Supporting materials for comment #123

Comment #123

D2.0 Figure 108-6

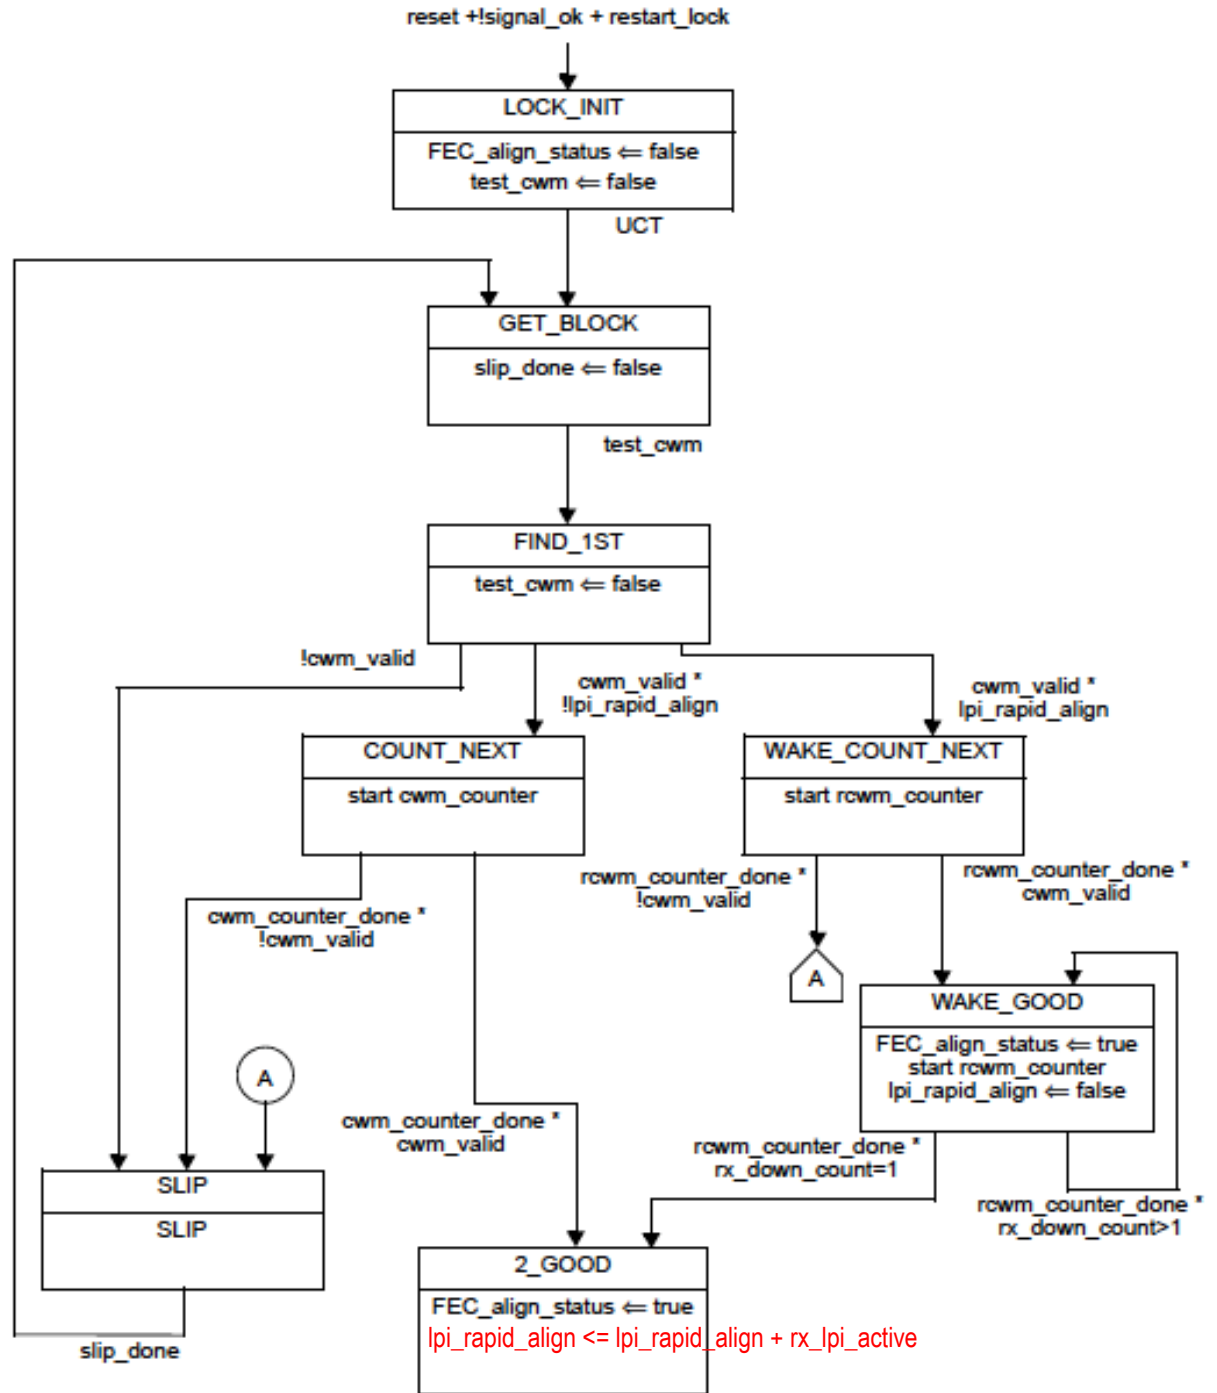
- This means `lpi_rapid_align` is a latched-high version of `rx_lpi_active` that only clears when you enter `WAKE_GOOD` state of Figure 108-6

Figure 49–12—LPI Transmit state diagram

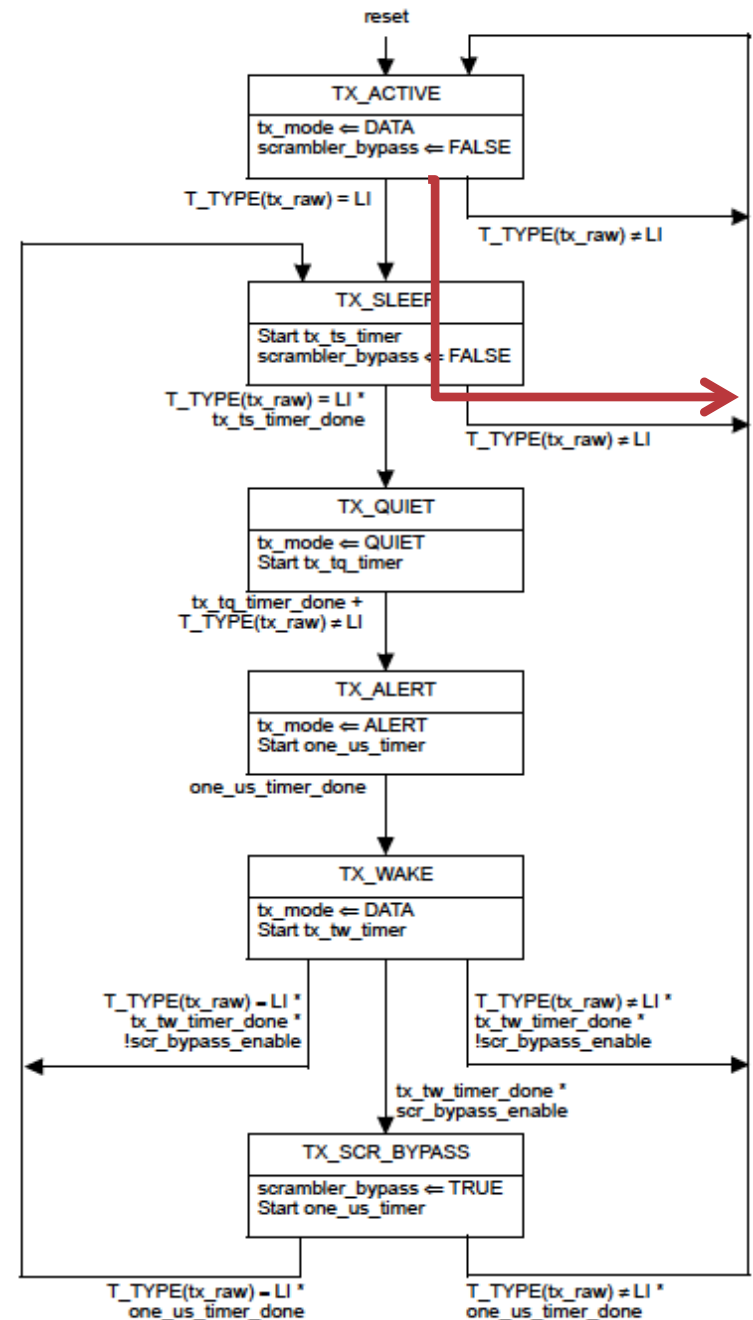
- In the Clause 49 PCS you can begin sending /LI/ and then go back to ACTIVE without ever going to sleep.
- This means 108 could receive some /LI/ which will set rx_lpi_active high, latch the lpi_rapid_align variable TRUE, then see // come through and deassert rx_lpi_active, but lpi_rapid_align stays TRUE and the link doesn't go to sleep.

Figure 49–12—LPI Transmit state diagram

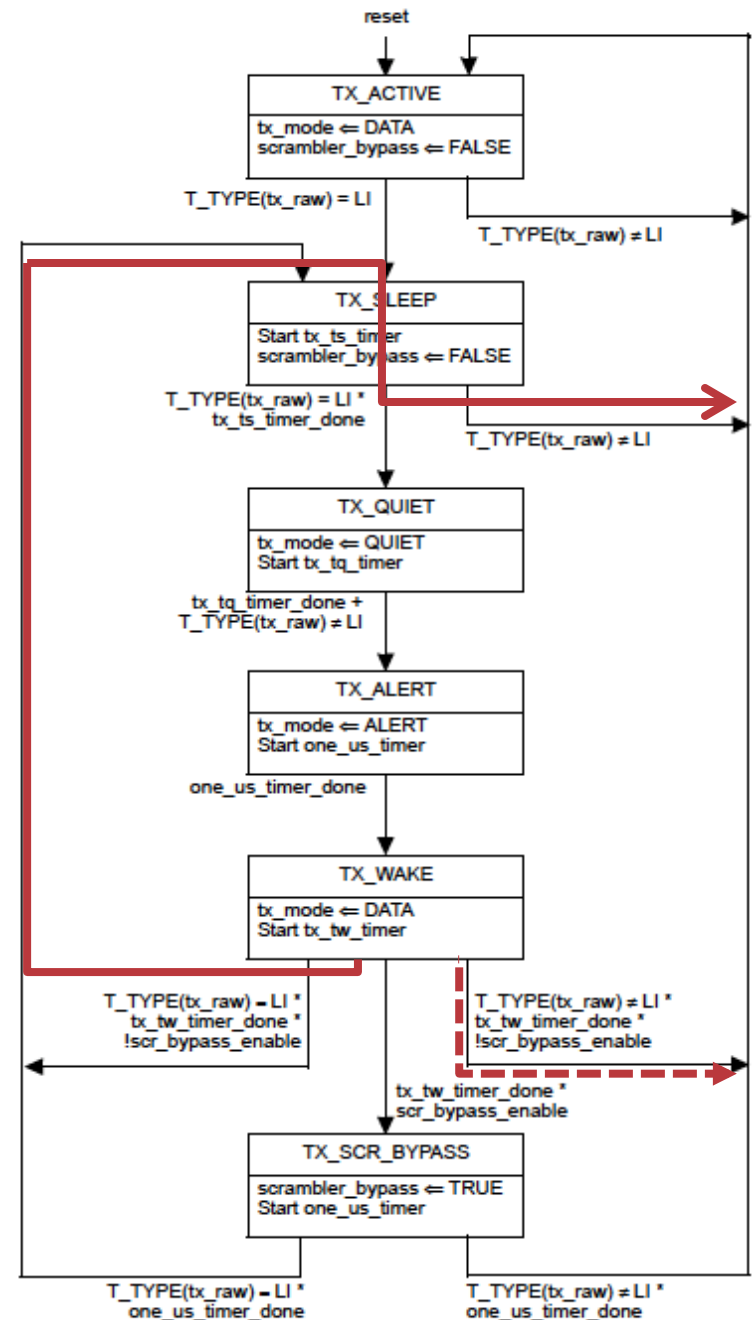
- Also during the WAKE process you could start with /LI/ being sent in the TX_WAKE state and then change it to // in the TX_WAKE or TX_SLEEP state and return to TX_ACTIVE.
- This also causes lpi_rapid_align to be latched TRUE when the Tx transitions from /LI/ to // after the Rx has reached 2_GOOD state

Flow Taken (lpi_rapid_align=FALSE)

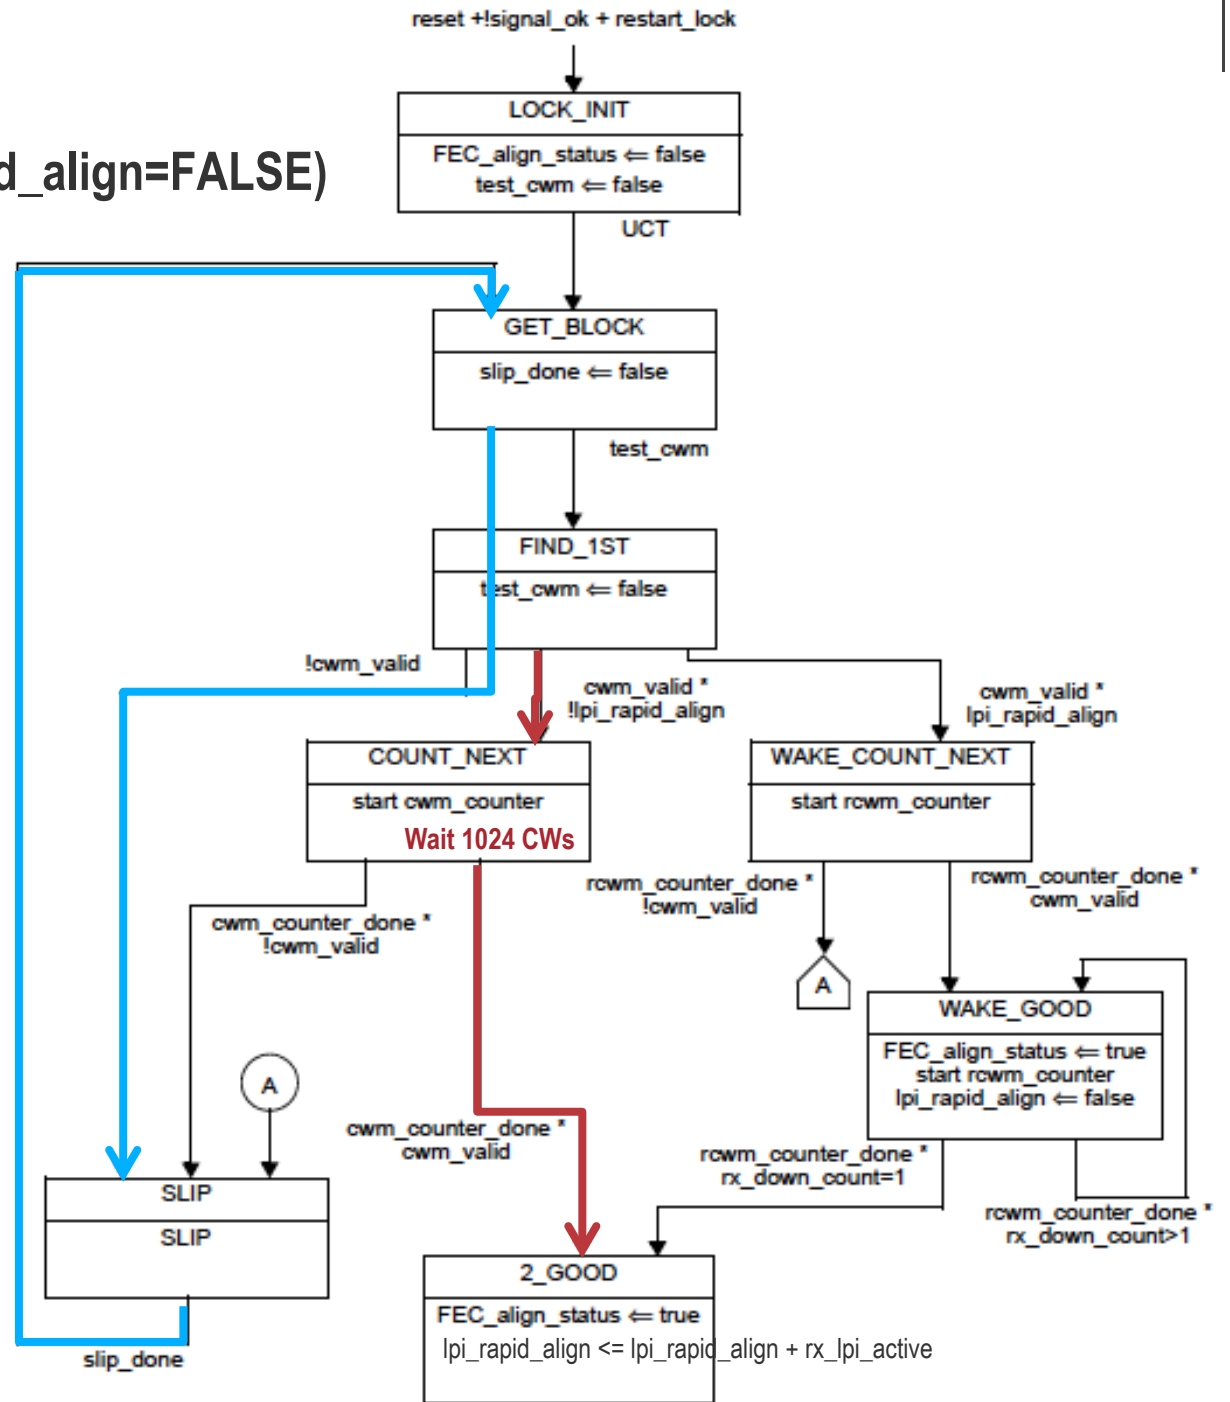
- Blue is taken until you locate the 1st CWM, then RED is taken to confirm lock

Flow Taken (lpi_rapid_align=TRUE)

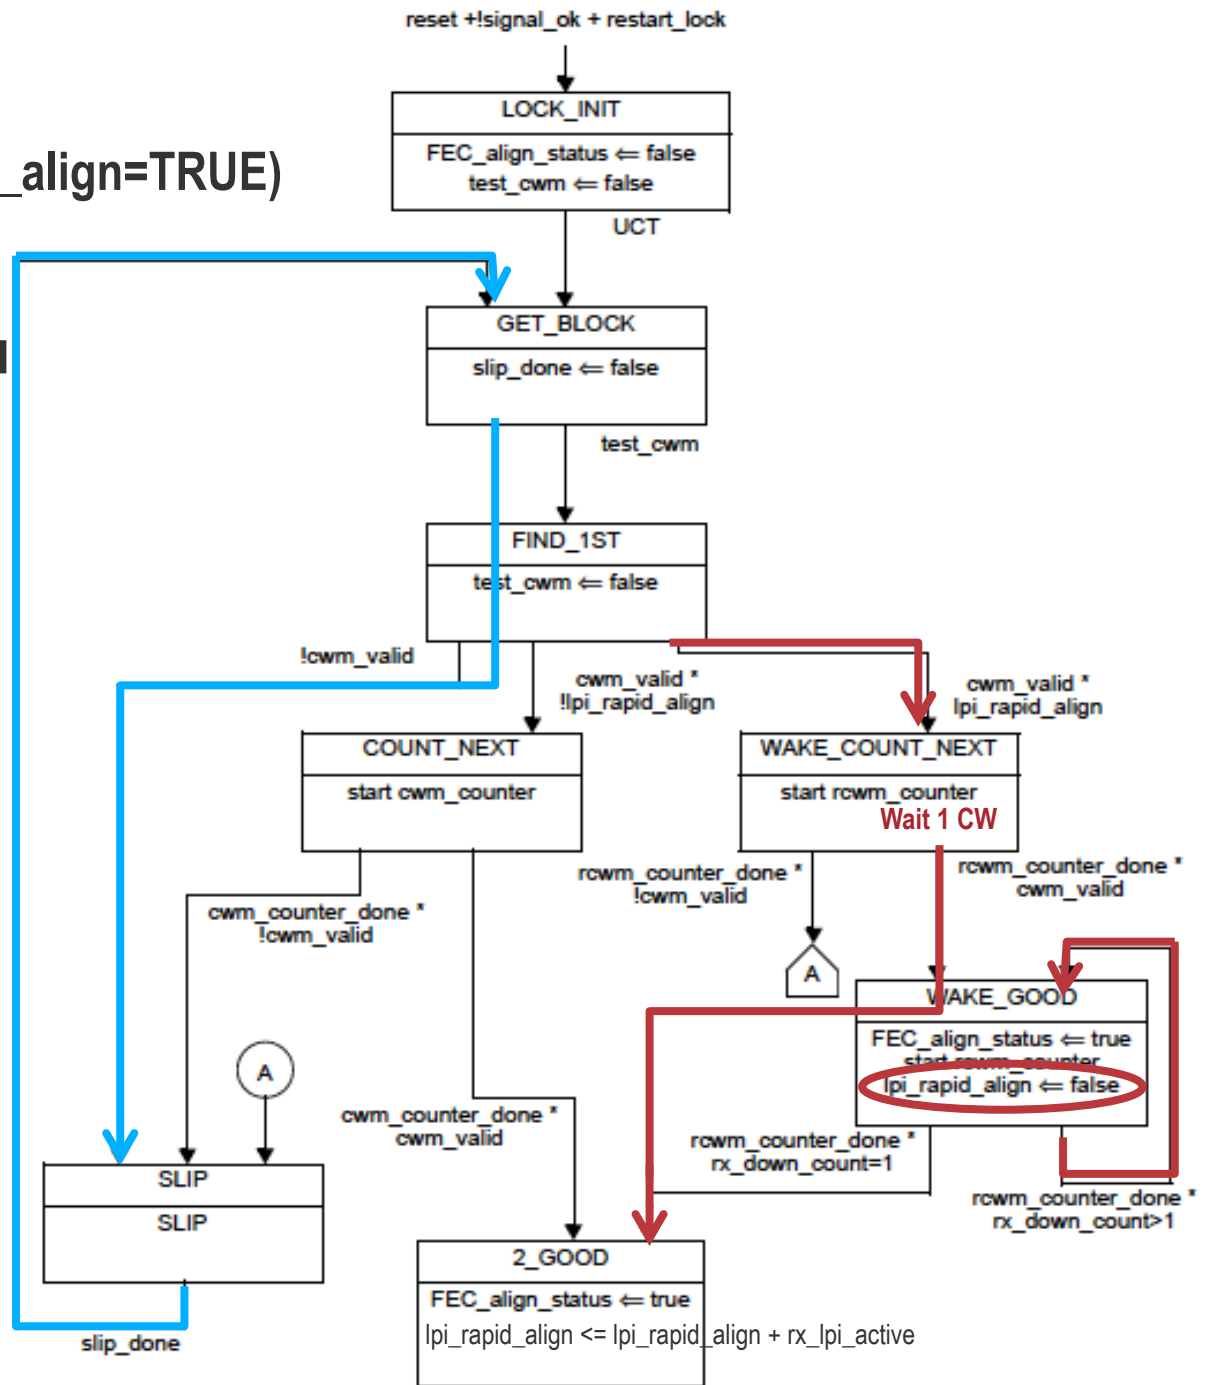
- Blue is taken until you locate the 1st RCWM, then RED is taken to confirm lock
- lpi_rapid_disable is cleared only after confirming lock
- Note that lpi_rapid_disable could be set immediately back to TRUE if /LI/ is being received

Flow Taken (broken)

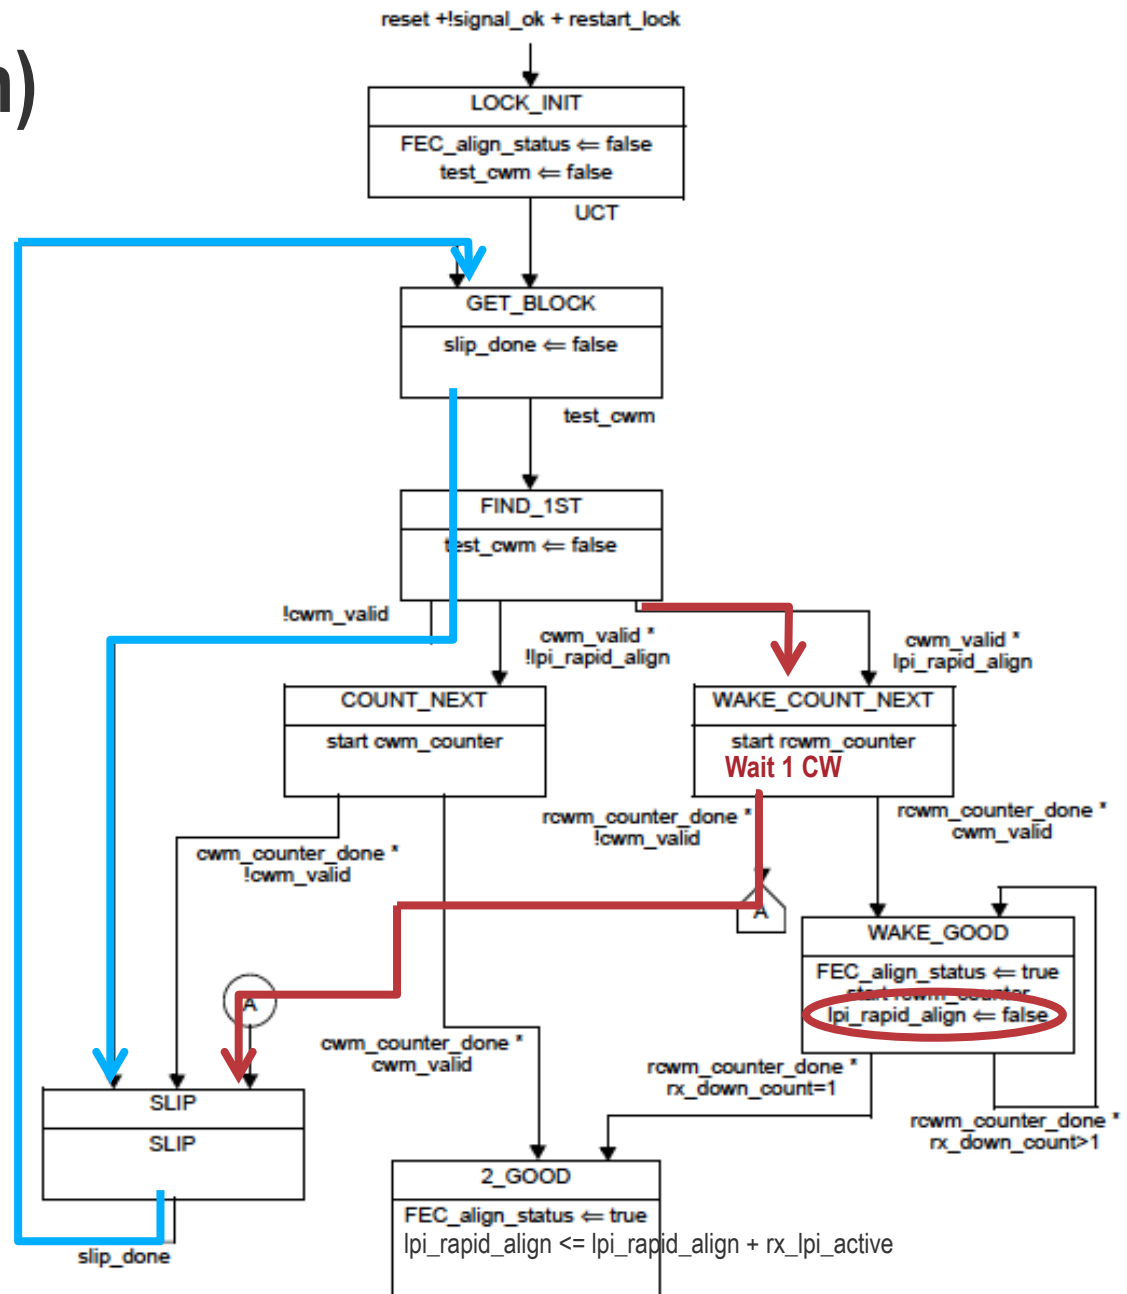
- lpi_rapid_align == TRUE, TX is in TX_ACTIVE state, Rx loses lock
- Blue is taken until you locate the 1st CWM/RCWM, then RED is taken to confirm lock
- Tx is sending CWM at 1024 interval instead of every CW, SM is stuck in infinite loop.
- Tx and Rx aren't in the same EEE state and there's no timeout in Rx to revert to non-EEE mode
